# UNITED STATES PATENT AND TRADEMARK OFFICE

APPLICATION NO.	FILING DATE	FIRST NAMED INVENTOR	ATTORNEY DOCKET NO.	CONFIRMATION NO.
10/626,993	07/24/2003	Gerald K. Hein		4168

## Office Action Summary

**DETAILED ACTION**

Fig. 5

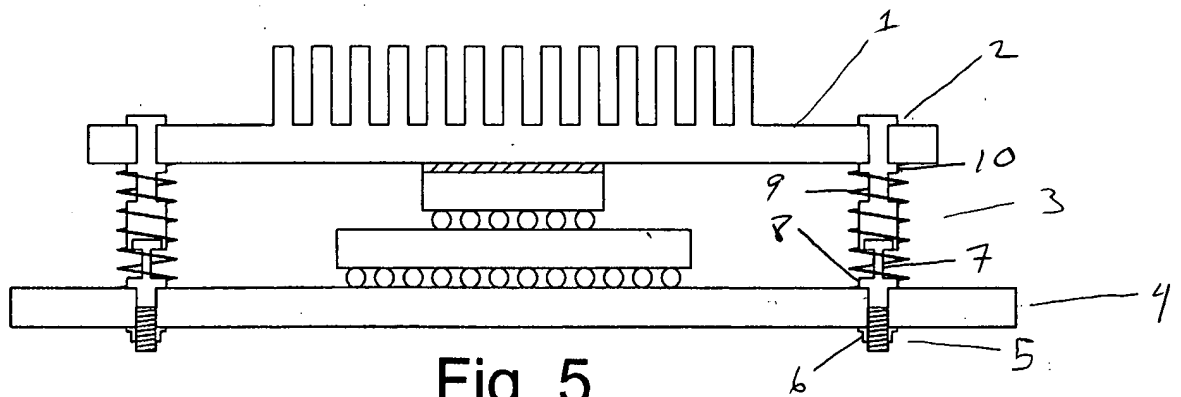
Claims 1 and 3 are rejected under 35 U.S.C. 102(b) as being anticipated by Pearson. (See marked up figures attachment I)

With respect to claim 1 Pearson teaches a heat sink assembly (Fig. 5) for removing heat from a semiconductor device (column 1, line 8) integrated circuit used in an electronic equipment apparatus, comprising a heat sink member (Fig. 5) having a body portion (Fig. 5, element 1) and a mounting portion (Fig.5, element 2) and attachable to the semiconductor integrated circuit (fig. 5 note the heat sink is attached to the semiconductor device), and a resilient mounting assembly (Fig. 5, element 3) positioned on the mounting portion of the heat sink member and arranged to permit the heat sink to be removably mounted (Fig. 5 note the screw threads on the mounting assembly) on a mounting member (Fig.5, element 4) which in turn is attachable to or part of a chassis portion (Fig. 5 note that mounting member 4 is capable of being attached to a chassis in a variety of known ways such as soldering or press fitting techniques) of the electronic equipment apparatus, wherein the mounting portion includes means for holding (Fig. 5 note the spring and screw thread on the mounting portion) the heat sink member to the mounting member when the heat sink assembly is operatively positioned on the mounting member.

With respect to claim 3 and with all the limitations of claim 1, Pearson teaches that the mounting portion (Fig.1, element 2) includes a base member (Fig.5, element 6)

and an upper member (Fig.5, element 7) which extends upwardly from the base member, the upper member having a slightly smaller cross-section than the base member, and wherein the mounting portion further includes an angled washer (Fig. 5, element 8) positioned on the base member, a spring element (Fig.5, element 9) mounted about the upper member above the washer, and a retainer element (Fig. 5, element 10) positioned above the spring element to hold the spring element on the upper member, and wherein in use the mounting member fits between the washer and the body portion (fig. 5) of the heat sink member, and wherein the spring element in action tends to hold the heat sink assembly and the mounting member together (Fig. 5 note that when the spring is in action the mounting member and the mounting portion are in direct contact) in a lower thermal resistance arrangement.
